Request for Class II Permissive Change

FCC ID: 2AJVQ-7668AUC

Data: February 8, 2021

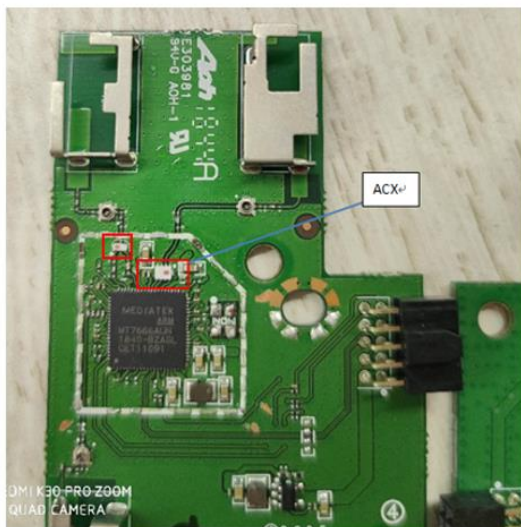
1. Add another factory's WIFI antenna duplexer.

New

Original

The antenna gain and antenna type are same as the original one

Antenna type: PIFA antenna

Antenna gain

2.4GHz

Antenna 0: 1.91dBi, Antenna 1: 1.31dBi

5GHz

Antenna 0: 3.52dBi, Antenna 1: 3.44dBi
